RapidIO™ Specification, Revision 3.0
RapidIO™ Specification, Revision 3.1

Errata Revision 2.1

Released 2/2016

RapidIO Specification Revisions 3.0 and 3.1 Errata Revision 2.1

Make the following change to the RapidIO Specification Revision 3.0 Part 6, Section 5.18.6, *Figure 5-29, Part 1*:

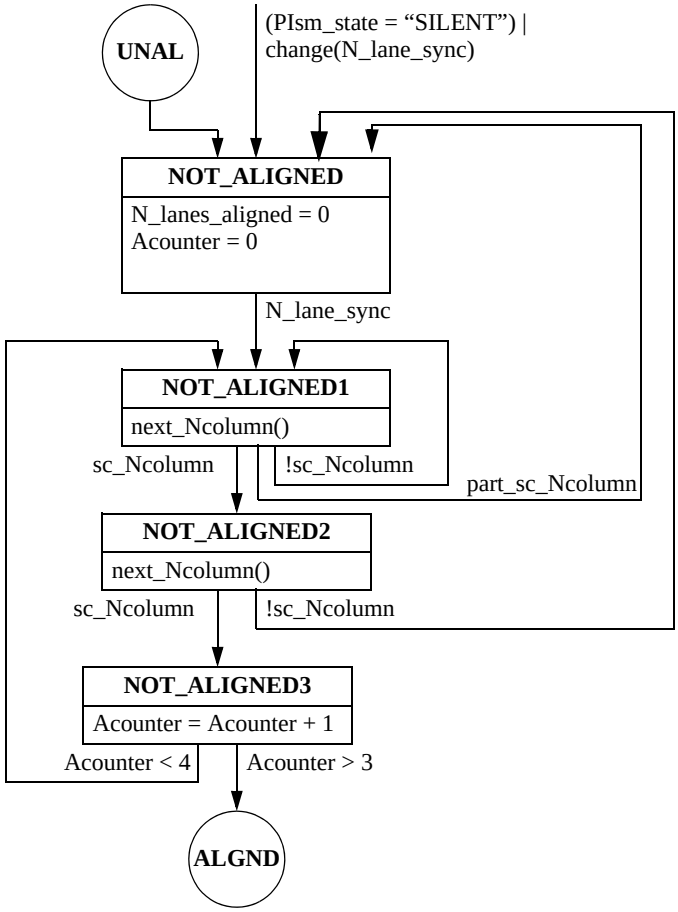
1. The 10xN lane alignment state machine must enter the ALIGNED state only after four consecutive SC ordered sequences have been received. The existing state machine must have a transition labelled “part_sc_Ncolumn” added from the NOT_ALIGNED1 state to the NOT_ALIGNED state. Change the 10xN state machine diagram as follows:

To ensure SC OS will be transmitted deterministically to operate the Retrain/Xmt_Width_Control FSM, in RapidIO Specification Revision 3.0 and 3.1, Part 6, Figure 5-34 Retrain/Xmt_Width_Control state machine is changed to the following:

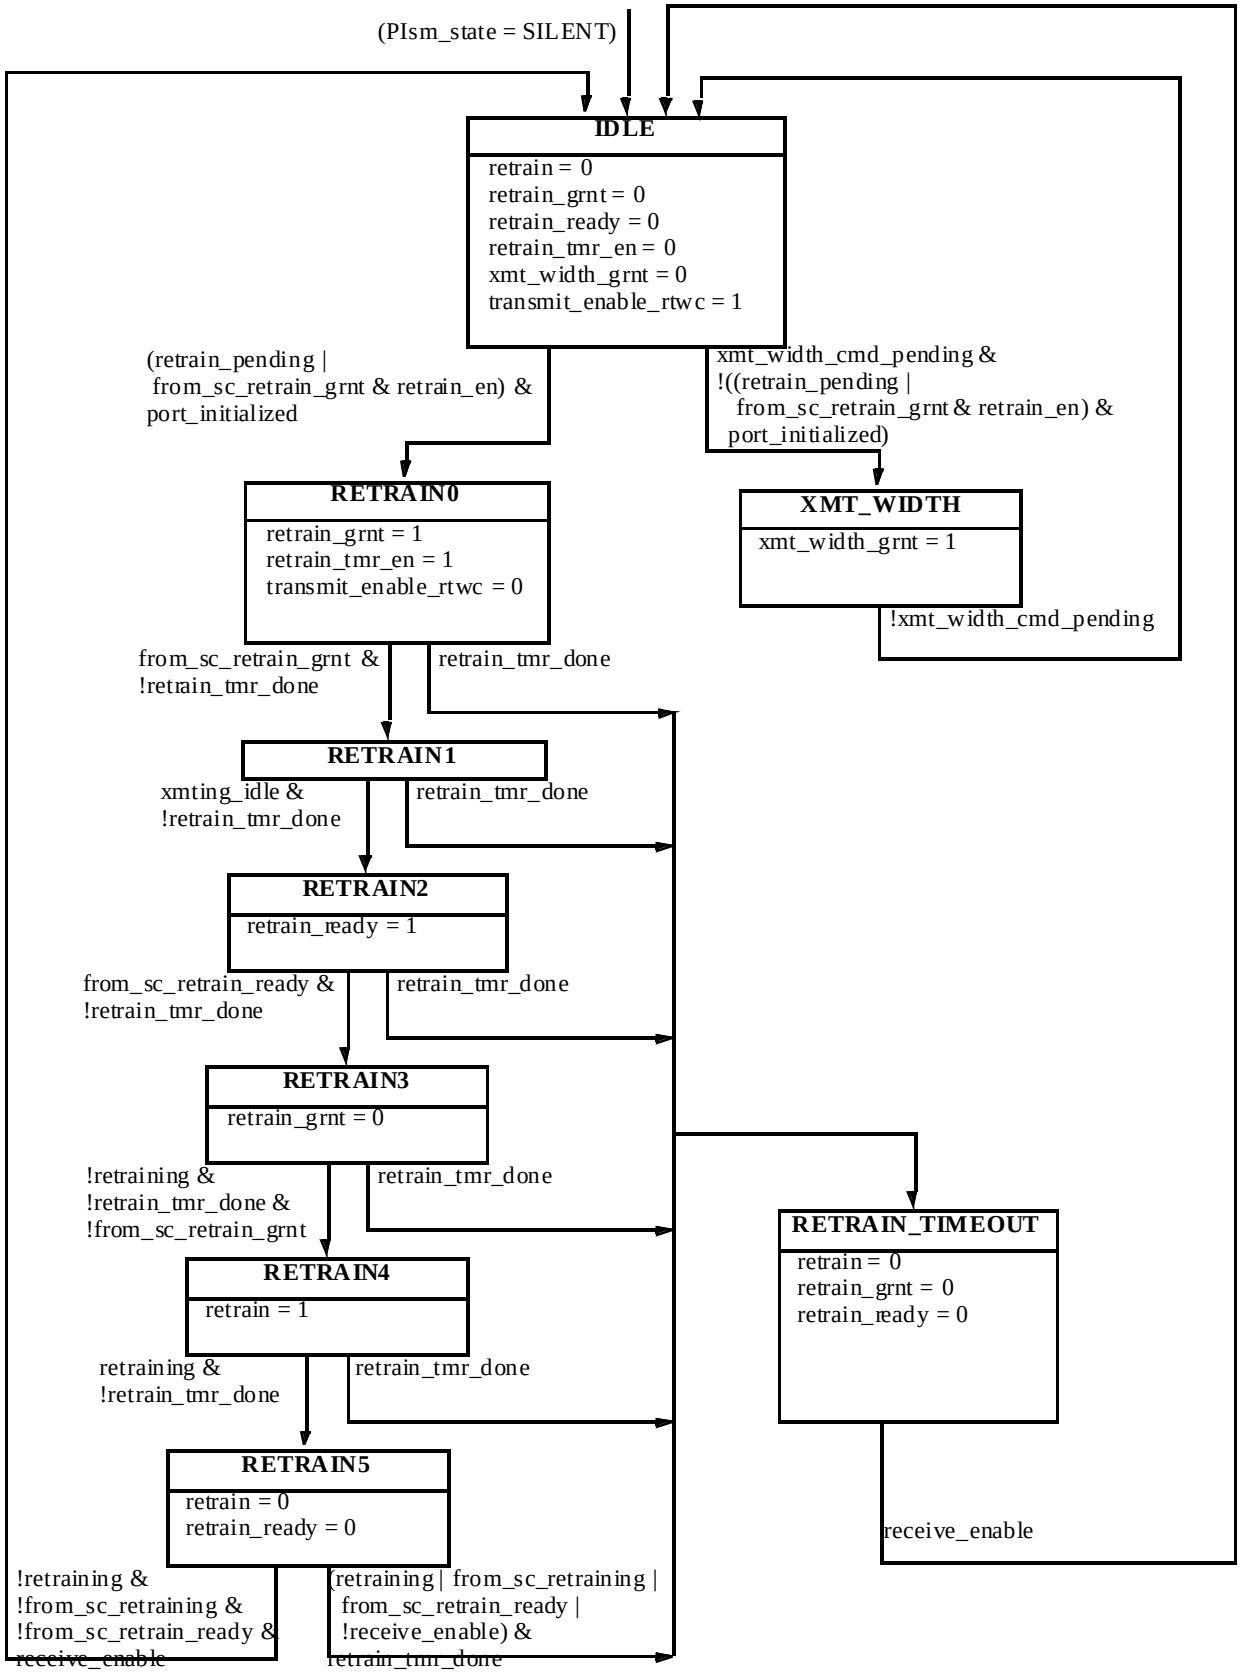
One of the objectives of the RapidIO standard is to ensure deterministic operation. This includes the operation of state machines dependent on values found in the Status/Control Ordered Sequence(SC OS). However, the definition of the Retrain/Xmt_Width_Control FSM is not deterministic when retraining is preemptive. The operation of this state machine is dependent on the exchange SC OS values but SC OS cannot be transmitted when near continuous traffic is being transmitted on a link. A “near continuous” traffic pattern that includes IDLE3 sequences which are always 18 codewords would never send an SC OS, based on the example implementation shown in RapidIO Specification Revision 3.0 Part 6, 5.10.2 Idle Sequence 3 Generation, Figure 5-18 “Example of a Pseudo-Random Idle Codeword Generator".

RapidIO Specification Revision 3.0 and 3.1, Part 6, figure 5-19. 1x Typical Data Flow with Control Symbol 64 is changed to be consistent with this definition:

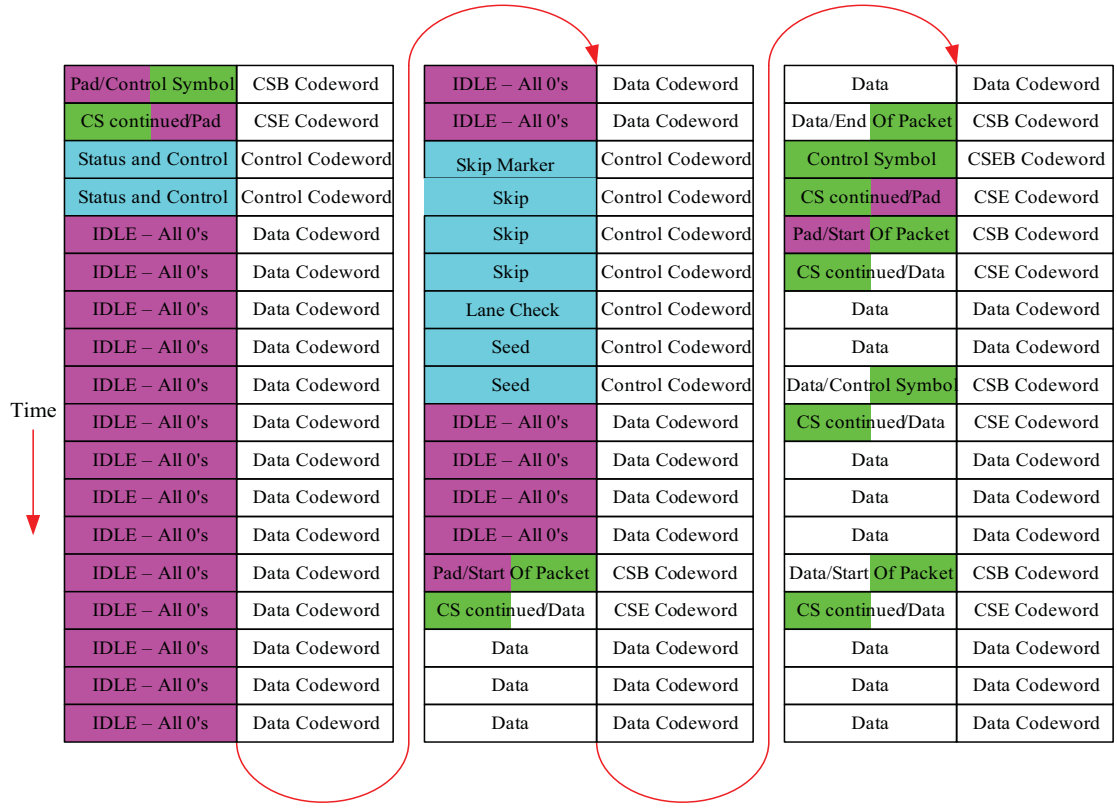
The definition of a skip ordered sequence is found in RapidIO Specification Revision 3.0 and 3.1, Part 6, section 5.9.3 Skip Ordered Sequence. It consists of the following sequence of control codewords:

- skip marker
- a number of skips
- lane check
- seed ordered sequence.
